HISTORIC AND DESIGN REVIEW COMMISSION

Agenda Item No: 25

HDRC CASE NO: 2016-269
ADDRESS: 2044 W HUISACHE AVE
LEGAL DESCRIPTION: NCB 1953 BLK LOT 16
ZONING: R6 H
CITY COUNCIL DIST.: 7
DISTRICT: Monticello Park Historic District
APPLICANT: Dulce Rivera
OWNER: Dulce Rivera
TYPE OF WORK: Addition, door replacement, window fenestration modification
REQUEST:

RIVERA RESIDENCE REMODEL

06 PROPOSED RIGHT ELEVATION
SCALE: 1/8"=1'-0"

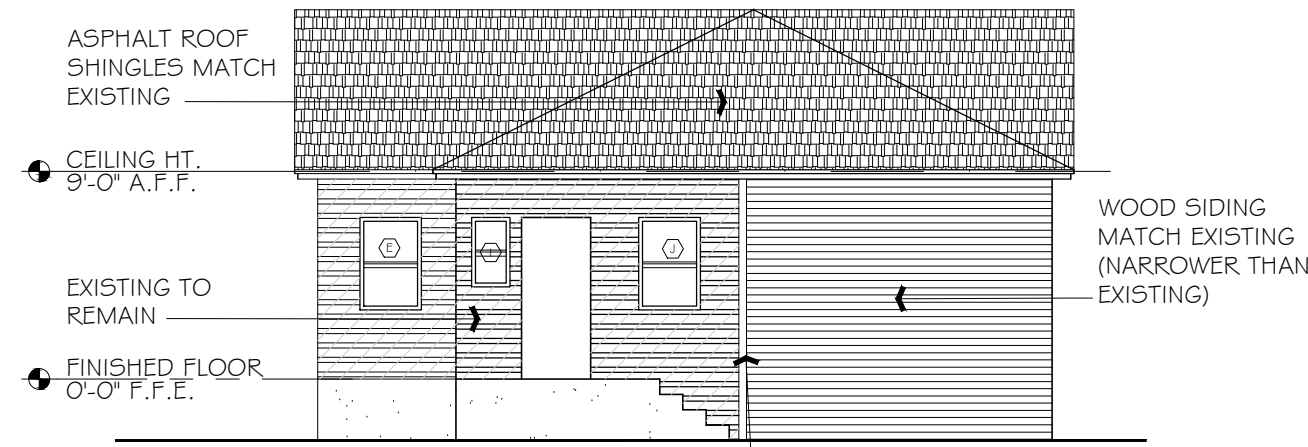
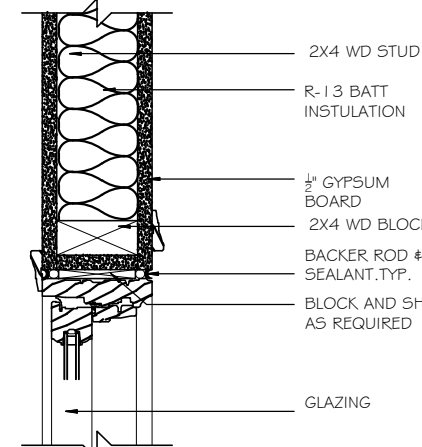
- g. **ARCHITECTURAL DETAILS** – The applicant is proposing to remove a square window from the right elevation of the existing structure and install it on the right elevation of the addition. According to the Guidelines for Additions, additions should incorporate architectural details that are in keeping with the architectural style of the original structure. Using the salvaged window proposed is consistent with the Guidelines, however, staff finds it would be more appropriate if the applicant incorporated the existing rear double window where the proposed addition is to be located to be salvaged and used in the addition.

- i. The applicant is proposing to remove a square window from the right elevation of the existing structure and install it on the right elevation of the addition. According to the Guidelines for Exterior Maintenance and Alterations 6.B.i, window openings should be preserved. Staff finds the removal of the windows where the addition to be located appropriate, but finds the removal of square window openings not consistent with the Guidelines. Staff recommends that the existing window opening be preserved and the applicant used the salvaged double window in the addition.

Staff recommends denial of item #3 based on finding i. Staff recommends that the existing side window be retained and the applicant salvage and reuse the existing rear double window in the proposed addition.

03 PROPOSED FLOOR PLAN
SCALE: 3/16"=1'-0"

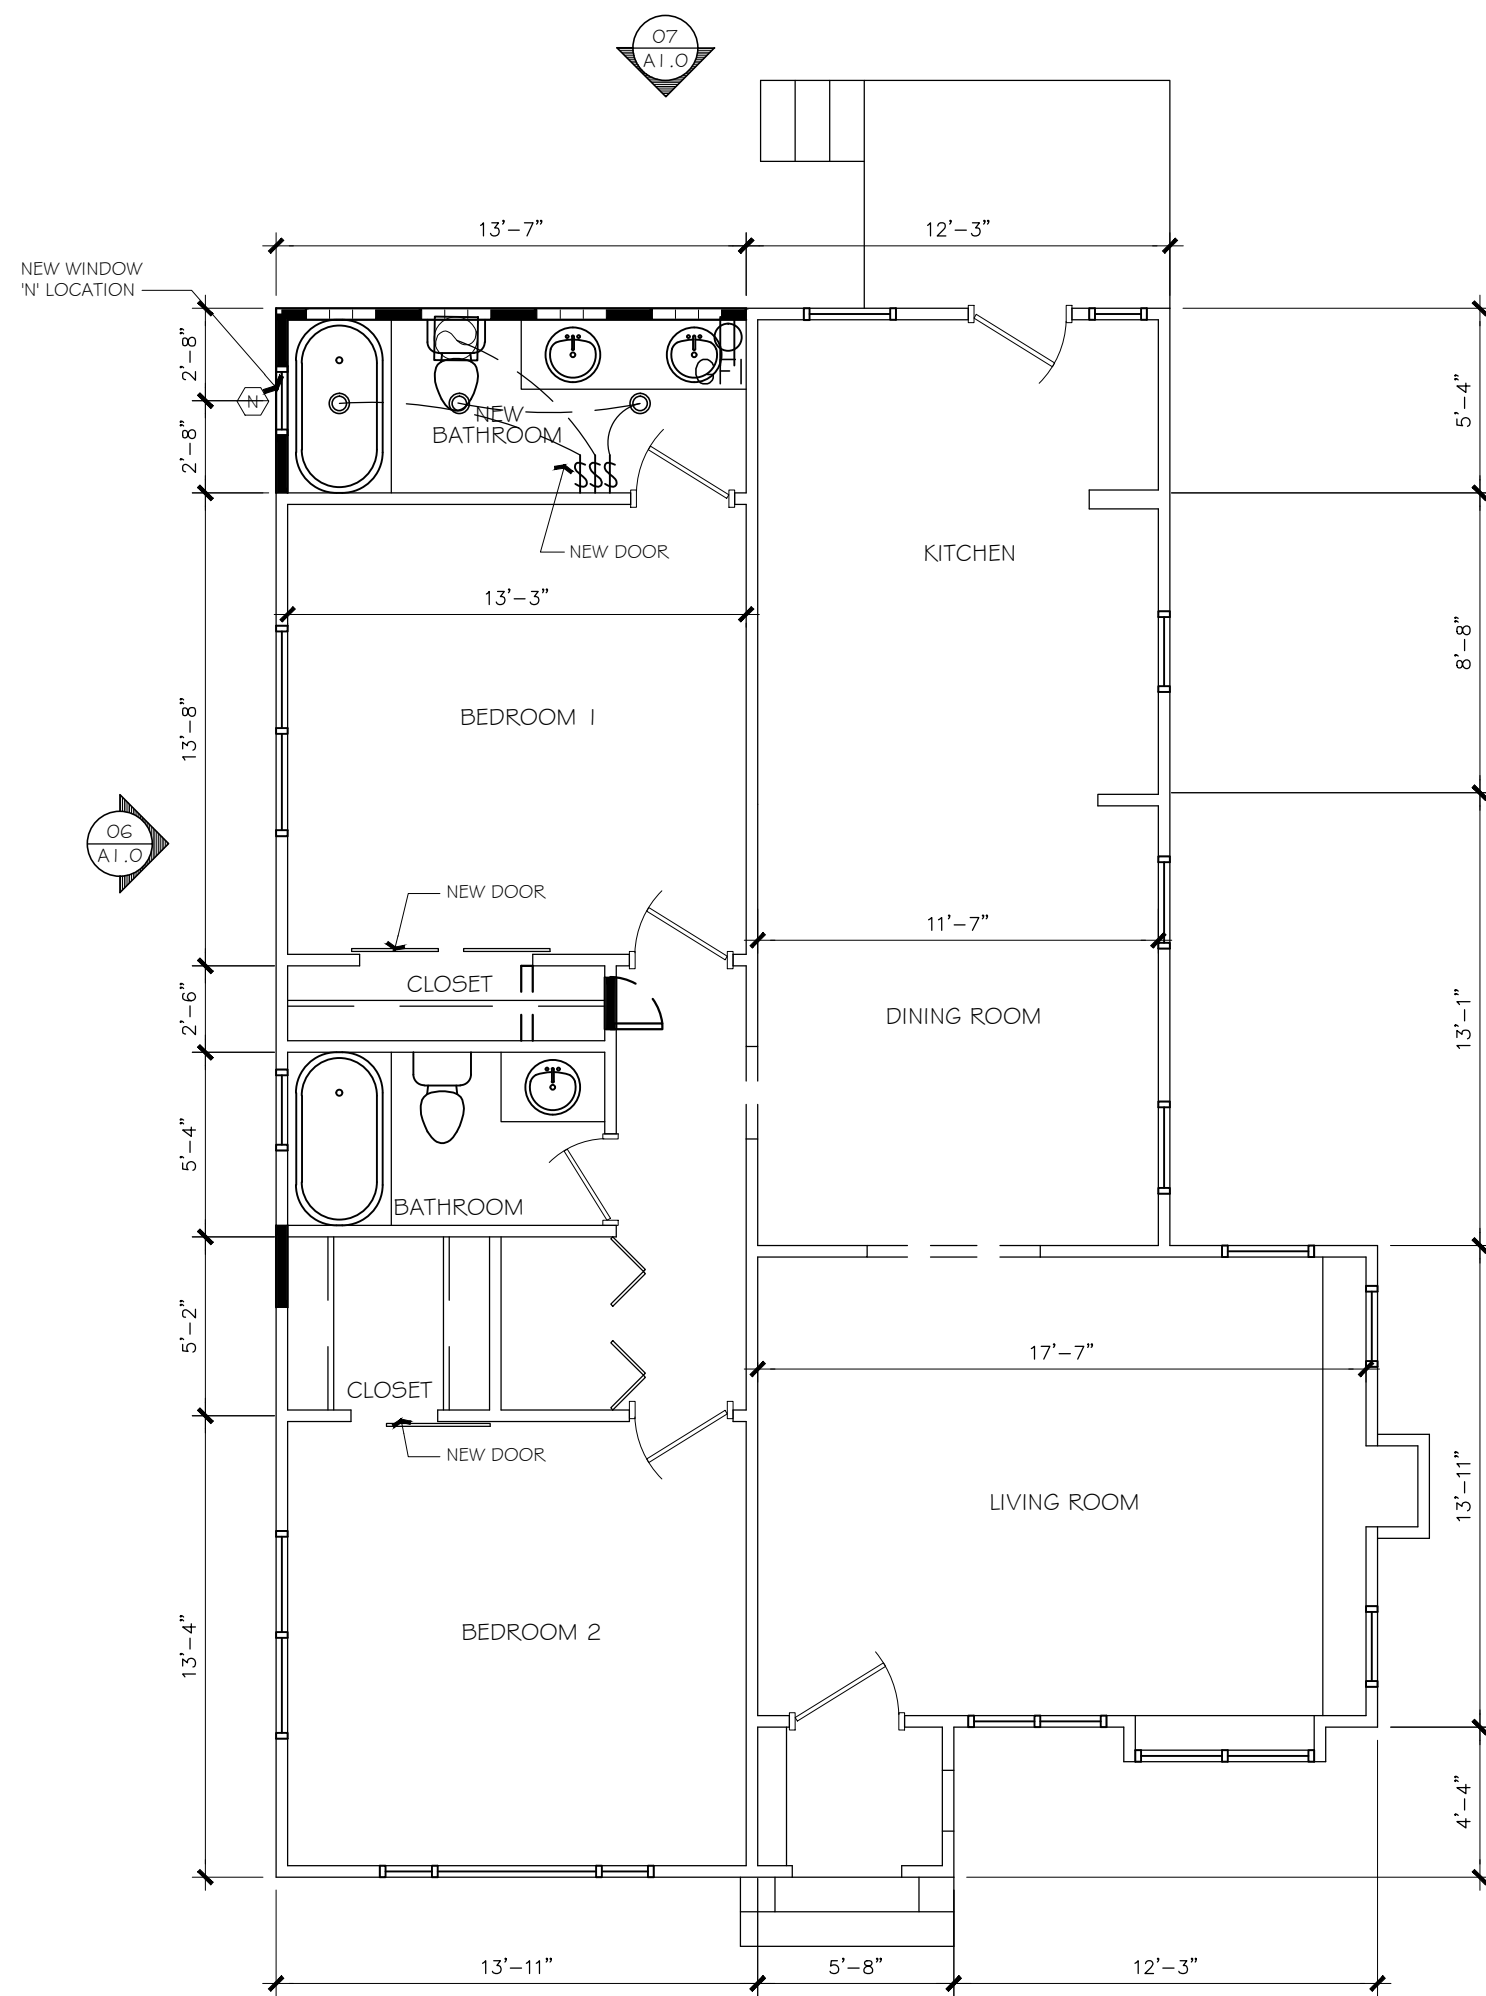
- f. **TRANSITION** – The existing rear foot print has an inset. The applicant is proposing to fill in that inset with the addition. According to the Guidelines for Additions, a transition between the primary historic structure and the addition is needed in order to differentiate the addition from the existing structure. The proposed addition features two 4” vertical trim pieces, indicating the start of the addition. Staff finds this consistent with the Guidelines and recommends the applicant recess the addition from the edges of the historic structure.

ReliaBilt French Insulating Core Blinds Between The Glass Full Lite Left-Hand Inswing Primed White Steel Prehung Entry Door (Common: 36-in x 80-in; Actual: 37.5-in x 81.75-in)

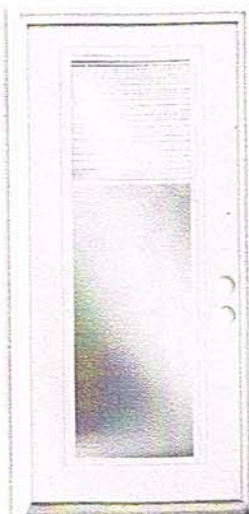
- h. The existing rear door is a non-original solid wood door. The applicant is proposing to replace it with a steel door with a full window light and insulated core blinds between the glass. According to the Guidelines for Exterior Maintenance and Alterations 6.B., non-historic windows should be replaced with those that are typical for the architectural style. Staff finds the steel door proposed is not consistent with the Guidelines. Staff recommends the door be made of wood.

Staff recommends approval of items #1 and #2 based on findings a through h with the stipulation that the rear door be made of wood.
